HADITHA DAM PERIMETER SECURITY HADITHA, IRAQ

SUSTAINMENT ASSESSMENT

SIGIR PA-09-192
APRIL 13, 2010

SUBJECT: Report on the Haditha Dam Perimeter Security, Haditha, Iraq (SIGIR Report
Number PA-09-192)

Figure 2. Contractor's design of typical fence section
(Courtesy of GRC)

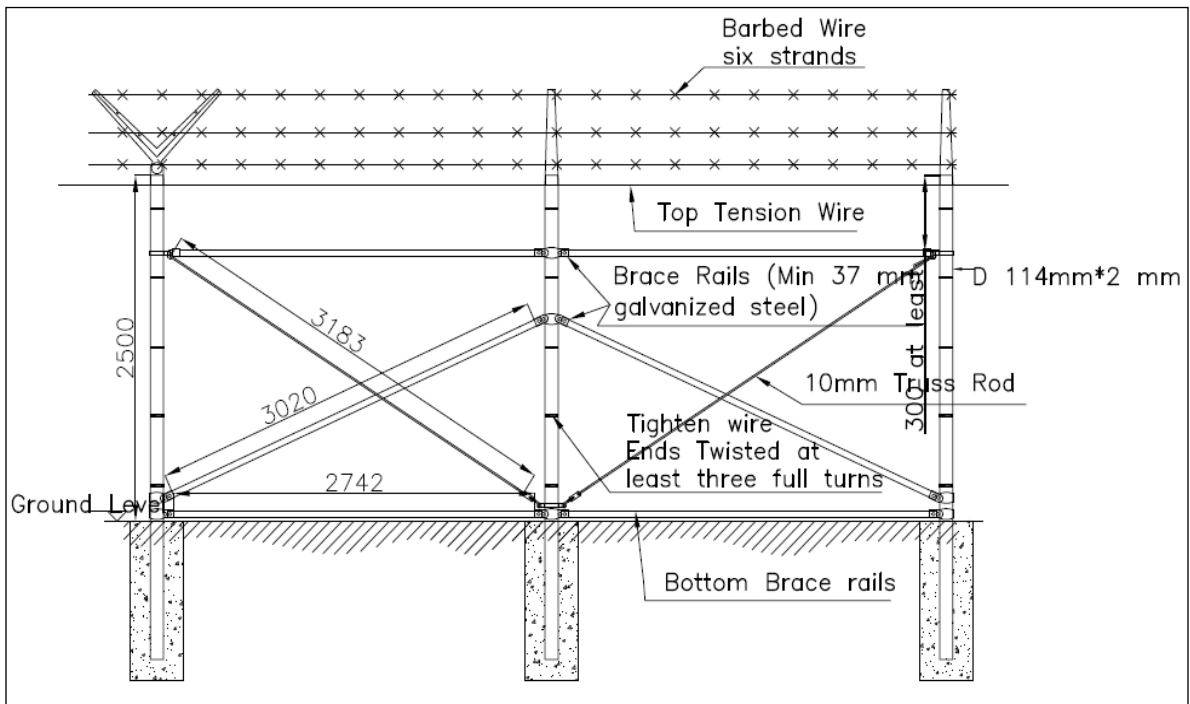
Some sections of the perimeter fence did not conform to the Uniform Facilities Guidelines Section 3231 or the USACE standard drawings for the security fence. Strands of barbed wire were not placed on the “V” shaped brackets along the top of the fence to contain the concertina wire coil. The contractor used concertina wire coil that is a single coil approximately 18 inches in diameter, instead of the contract-required interlaced double coils of 24 and 30 inch diameter.

The contractor attached the chain link fabric to the fence posts with steel bands at 32 inches on center. The attachment did not conform to the 15 inches on-center requirement of the USACE standard drawings for a security fence, and was not consistent with the 18 inches on-center indicated on the contractor’s drawings.

The fence brace rails were different dimensions than shown on the contractor’s drawings. The brace rails were attached to the pull post approximately 36 inches above the post base, instead of 58 inches as shown on the contractor’s drawings. The difference will affect the ability of the brace panel to resist tension from the chain link fabric.

The concrete anchorage for the fence posts was approximately 8 to 12 inches deep (Site Photo 6), which was inconsistent with the contractor's design drawings that showed a 45 inch depth for a typical line post. The configuration of the concrete anchorage was not consistent with the contractor's design plans and tapered from approximately 16 inches in diameter at the top to 8 inches in diameter at the base of the post, instead of the required uniform diameter of 16 inches. In addition, the anchorage did not cover the end of the post as shown in the design drawings, which will allow for increased corrosion of the post.

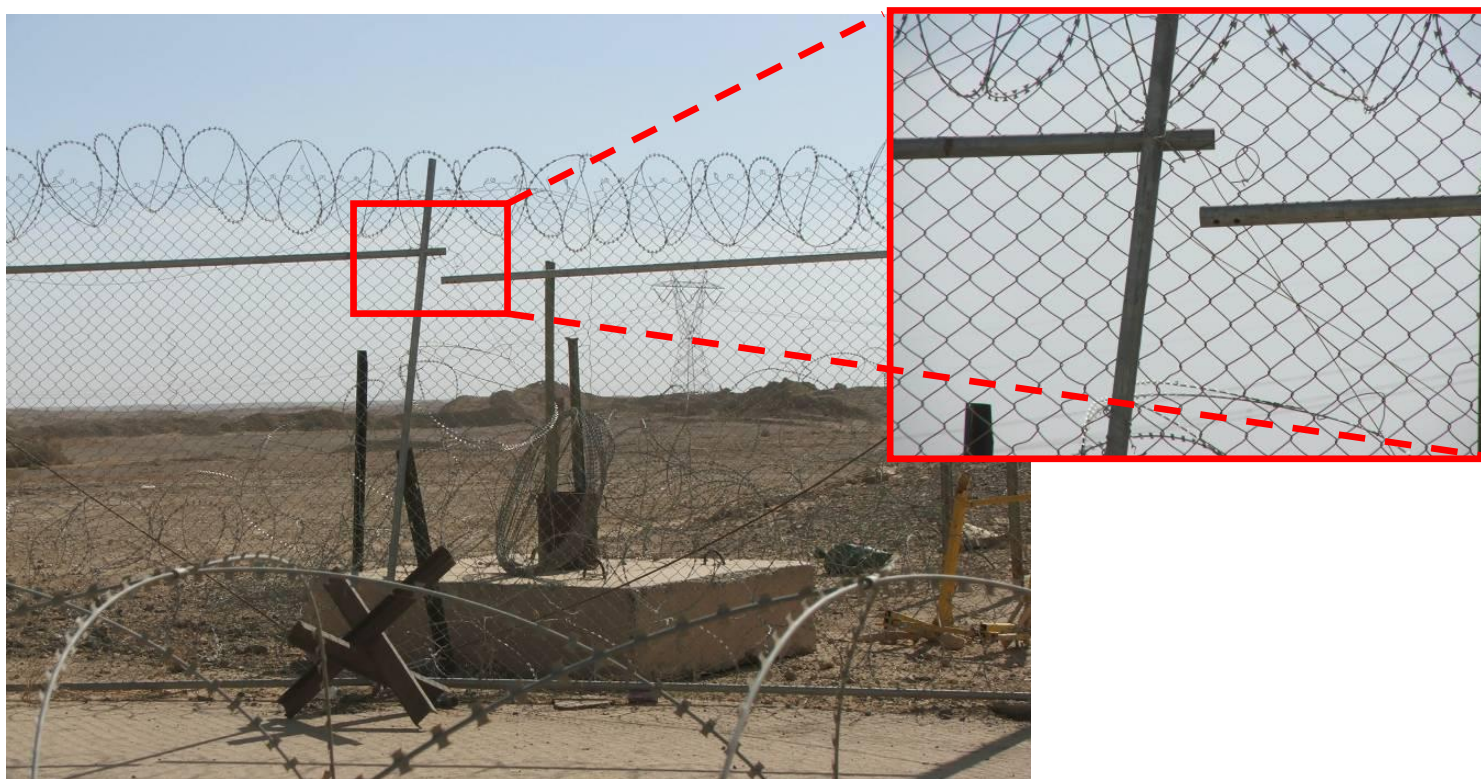
The entry point was constructed completely opposite of the contractor's submitted design plans. The contractor's plans indicated a reasonable method of controlling entry to the facility by using "Jersey" barriers and a lifting gate to slow vehicles prior to reaching the security fence. However, as constructed, vehicles first reach the swing gate in the security fence. After entering the secure area, vehicles are then confronted with the lifting gate, and finally directed through the chicanes into the facility. This configuration contributes little to force protection and allows vehicles to approach the secure area without any method to control speed or direction.
